Office Action Summary

10/549,305

KUGE ET AL.

DETAILED ACTION

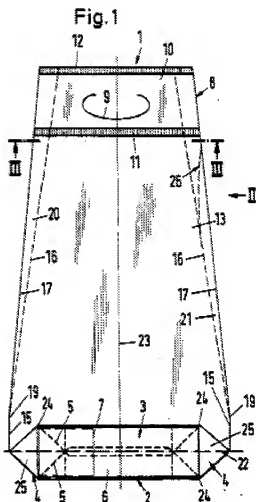
10. In re Claim 1, Bronstrup et al (Figure 1 shown above) teaches a fastener bag comprising:

A pair of opposed flat surface portions (13, 14) and a pair of side surface portions (15, 16) disposed between both side edges of the flat surface portions (13, 14), the side surface portions (15, 16) being folded inward (20, 21) so as to provide a gusset-type bag (1),
